November 2, 2020To:Depoe Bay Planning CommissionFrom:Jaime White, City PlannerRe:Update to Staff Report

UPDATE: A request for Variance Public Hearing was held at the October 13, 2021 Planning Commission meeting for Case File #2-VAR-PC-21. The Planning Commission decided to continue the hearing until the next regularly scheduled Planning Commission meeting (November 10, 2021) in order to allow the city planner and applicant to gather additional items requested by the Planning Commission.

#2-VAR-PC-21 Lisac October 13 & November 10, 2021 Planning Commission Meetings

BUILDING ELEVATIONS

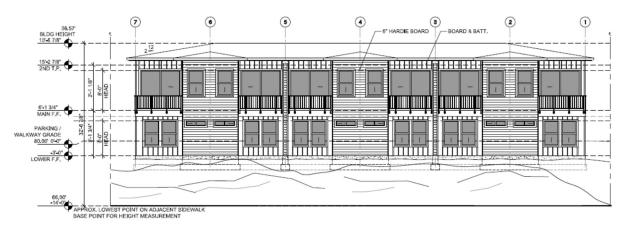
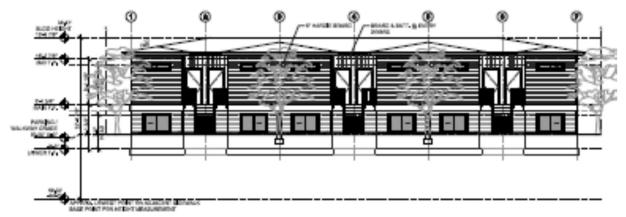
South Elevation for Buildings Along US HWY 101. Elevations are measured from HWY 101 sidewalk (66') to top of building (98.57'). Total building height is 32.57'.

West Elevation for Buildings Along US HWY 101.

East Elevation for Buildings Along US HWY 101.

Figure 2 – Trip Distribution Map (© Google Earth)

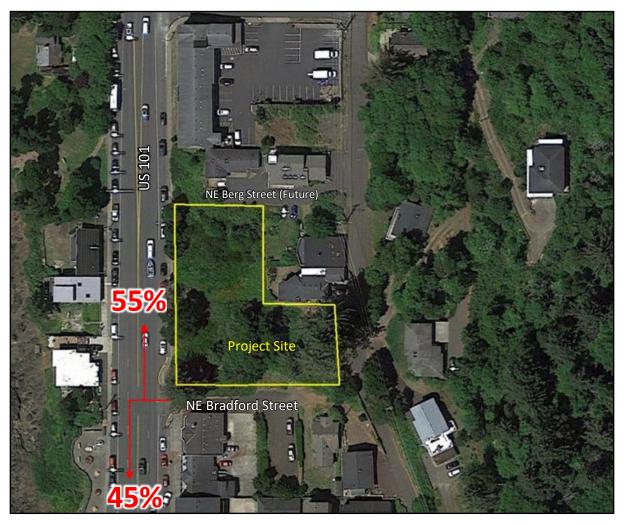
- Approximately 55 percent of trips will travel to/from the north along US 101. This traffic will use NE Bradford Street to access the highway north of the site; and
- Approximately 45 percent of trips will travel to/from the south along US 101. This traffic will use NE Bradford Street to access the highway south of the site.

The only movement with potential to add delay to the highway is inbound site traffic coming from the north on US 101, which is expected to turn left onto NE Bradford Street. Because US 101 is four lanes with no center refuge lane, vehicles will make the left-turn movement from the inner shared left-through lane. Left-turning vehicles will need to cross two lanes of northbound traffic. Through vehicles will have the opportunity to go around vehicles waiting to make a left turn, thereby reducing the impact of obstructing the flow of traffic. The signalized intersection at Bay Street is expected to create regular gaps in the northbound traffic stream for sufficient ingress, even during the most congested conditions. No northbound queues are likely block this movement are no traffic signals within serval miles north of the site that would otherwise create significant northbound congestion. It should also be noted that this intersection configuration is consistent with many intersections throughout the corridor, matching the character of the existing roadway environment.

Wide sidewalks and pedestrian amenities just S. of Bradford looking S. (rock wall removed in 1990s)

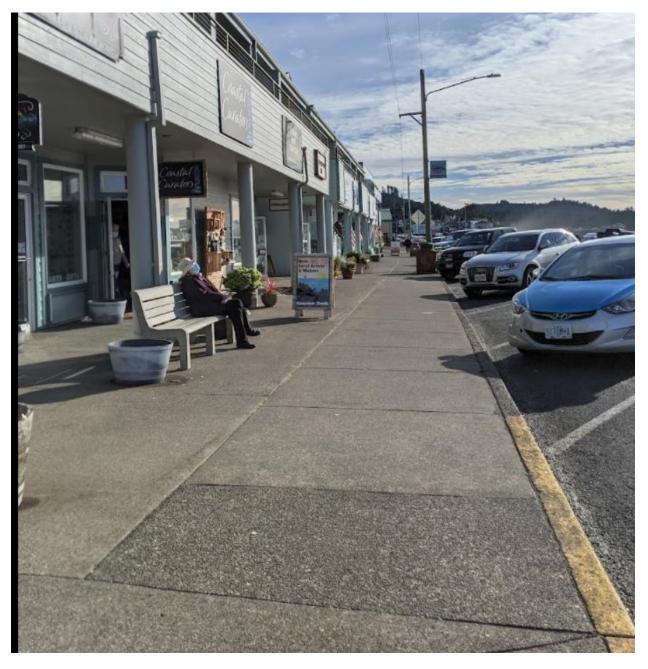
Another close up view, just S. of Bradford looking N
